MAJOR PROJECT ASSESSMENT:

***Adaptive Reuse of the existing buildings on
Blocks 6 and 7***

***Central Park, Chippendale (Former Carlton
United Brewery)
MP11_0091***

Director-General's
Environmental Assessment Report
Section 75I of the
Environmental Planning and Assessment Act 1979

Figure 3 – Concept Plan Analysis 3D perspective and plan view (source: TZG)

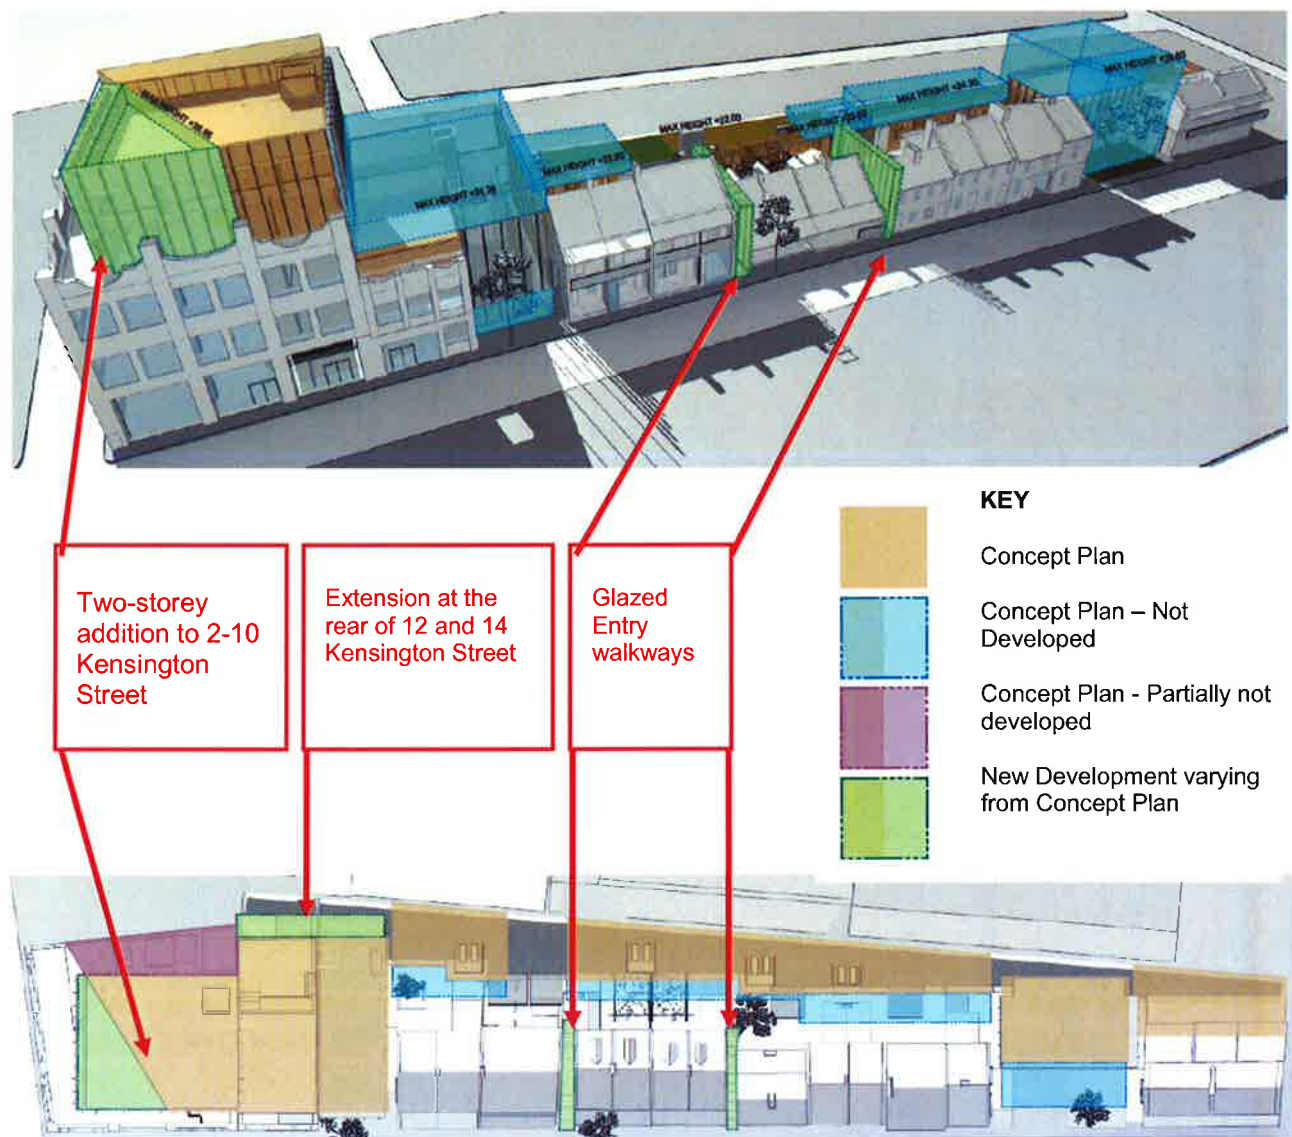
The proposed two-storey addition to 2-10 Kensington Street complies with the maximum building height approved by the Concept Plan. However, the proposed alignment of the northern elevation of the new two storey addition, varies from the approved Concept Plan. The approved Concept Plan envelope has a splayed building alignment on the northern elevation (**Figure 3**).

The Department raised concern, that the modified alignment could result in negative visual impacts when viewed from the public domain. The Department suggested that consideration should be given to aligning the north façade of the proposed addition parallel with the alignment of the existing building below.

From an urban design perspective the Department considers that the proposal is acceptable. The proposed two storey addition is designed as a light weight glazed structure, providing a contemporary addition in contrast to the historic fabric of the existing building below. The proposed design is considered to provide an appropriate contemporary response to the heritage context of the existing building and the surrounding area. The Department also notes that Council and the Heritage Council of NSW did not raise any concerns regarding the proposal. The Department therefore considers that the modified building alignment is acceptable.

Figure 4 – 3D views of alignment of addition to 2-10 Kensington Street (source: TZG)

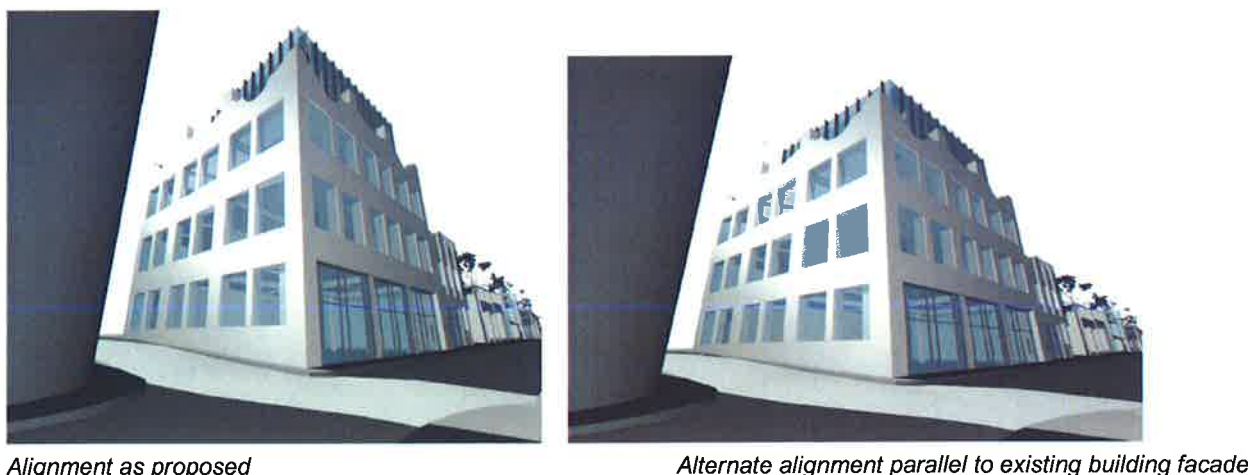
In the RtS, the proponent prepared 3D model views illustrating the proposed visual impacts of the proposed and an alternate parallel alignment of the upper floor addition (**Figure 4**).

The Department has considered the 3D photomontages and accepts there will be little discernible difference in the alternate alignment of the roof top addition to 2-10 Kensington Street, when viewed from street level.

Figure 5 – Approved and proposed building envelopes at 12 and 14 Kensington Street (source: TZG)

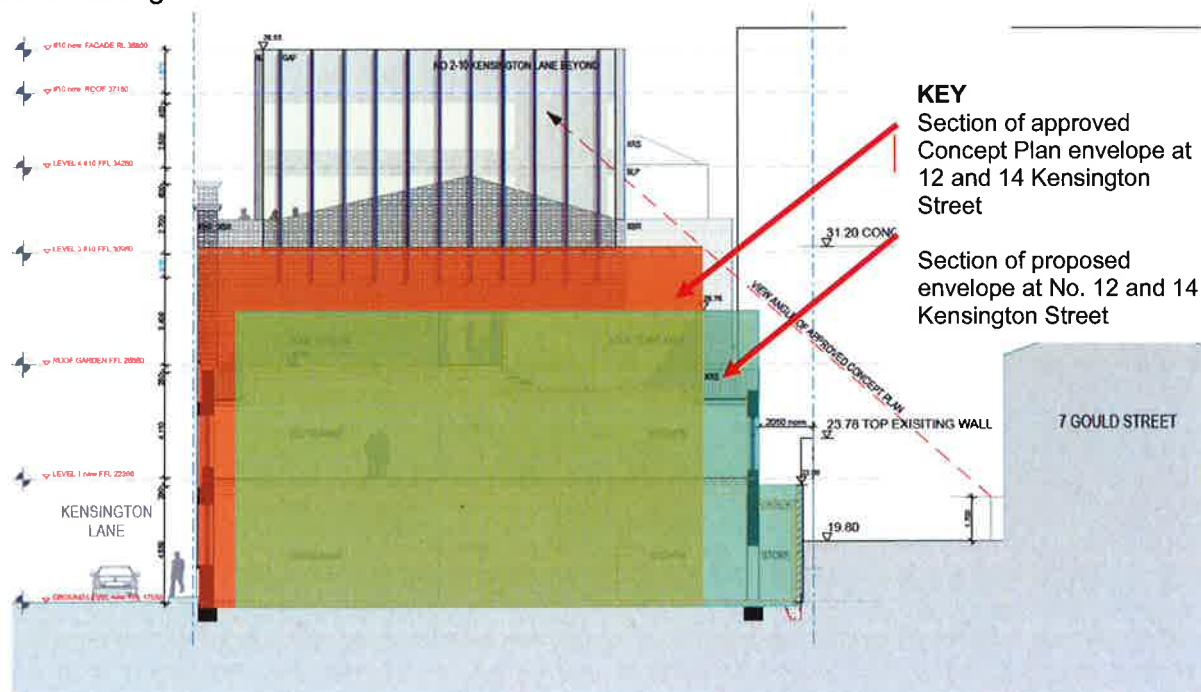
Concern was raised in the public submissions that the proposed variation to the Concept Plan building envelope to 12 and 14 Kensington Street could result in negative amenity impacts to adjacent residential properties to the east. The submissions requested that diagrams indicating the angle of views from adjoining properties be provided, to allow an assessment of impacts on views and potential overshadowing impacts.

The ground floor level of the site is 200-400mm lower than the adjoining properties to the rear. Although the proposed rear addition would be closer to the property boundary than the Concept Plan building envelope, due to the varied site levels, the building at the boundary, would sit below the existing boundary wall (**Figure 5**).

In the RtS the proponent provided a diagram comparing the approved Concept Plan and proposed building envelopes (**Figure 5**), which illustrates that the angle of view from adjoining properties would not vary from the approved Concept Plan building envelope. The shadow diagrams submitted with the EA also demonstrate that no additional overshadowing of neighbouring properties would occur as a result of the proposed change to the approved Concept Plan envelope.

The Department is therefore satisfied that the proposed extension to the Block 6 building envelope is acceptable. The stepped building form and the lowering of the maximum building height would mean that there are no negative impacts on surrounding properties in terms of visual views or overshadowing.

Figure 6 – Kensington Street Elevation showing the proposed glazed entry walkways (source: TZG)

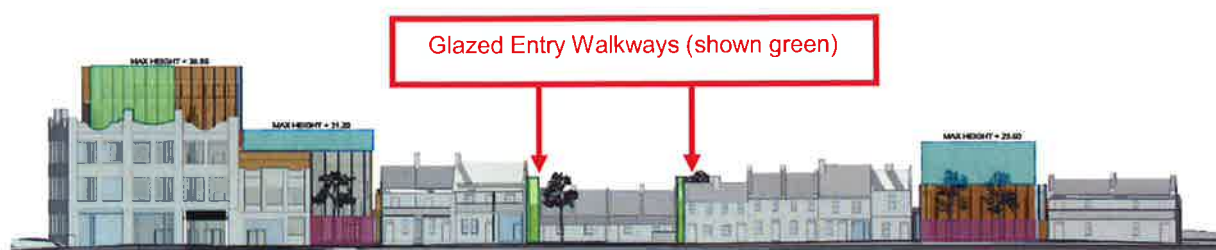
The proposal includes the construction of two separate glazed walkways located between Nos. 20-22 and 28-30 Kensington Street. The glazed walkways would provide pedestrian access from the street to the rear courtyards of the existing terraces fronting Kensington Street. The glazed

walkways are variations from the approved Concept Plan building envelopes. The glazed walkways are to be constructed of transparent glazing and steel frames (**Figures 6 and 7**).

From an urban design perspective, the Department considers that the proposed glazed entry walkways would provide a contemporary design response to the existing terraces. It is also considered that the proposed entry walkways would be visually sympathetic to the heritage context of the site due to the use of light weight transparent materials. The variation is therefore considered acceptable.

Figure 9 – Amended design of proposed Pocket Park (source: Jeppe Aagaard Anderson and Turf Design Studio)

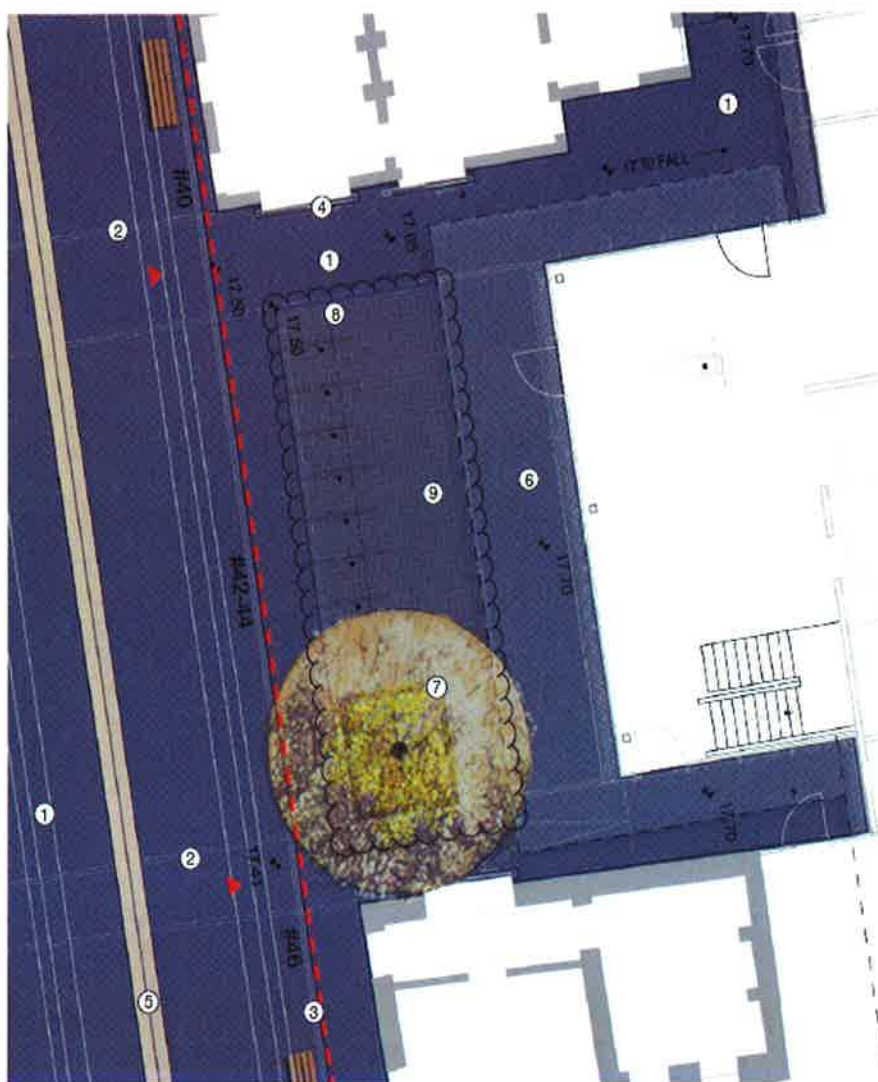
Council supported the proposed public park, as exhibited in the EA, however raised concerns that the percentage of paved surfaces was excessive and recommended the design be amended to incorporate a minimum 10% of porous and semi porous surfaces. Council and the Department also recommended that materials and planting be used in the design of the pocket park to clearly define recreational and trafficable spaces.

The RtS incorporates additional landscaping and deep soil planting in the pocket park. The revised drawings show some additional soft landscaping and permeable paving. The revised landscape plan also indicates a new proposed large tree to be planted in the deep soil zone, which will provide shade and a pleasant environment and enhance the amenity of this space for employees and visitors to the site (**Figure 9**).

Both the Department and Council support the revised park design which would provide clear definition between the varied spaces. However, the revised design is not considered to have addressed concerns in relation to the need to provide additional soft landscaping or street furniture to maximise benefits of the park. Therefore, a condition is recommended to require the submission and approval of a further landscape design for the pocket park, to be approved by Council, prior to the issue of a Construction Certificate (**Condition B20**). Subject to this condition, and the above mentioned condition relating to bicycle parking, the Department is satisfied that the proposal would result in a positive streetscape impact to Kensington Street.
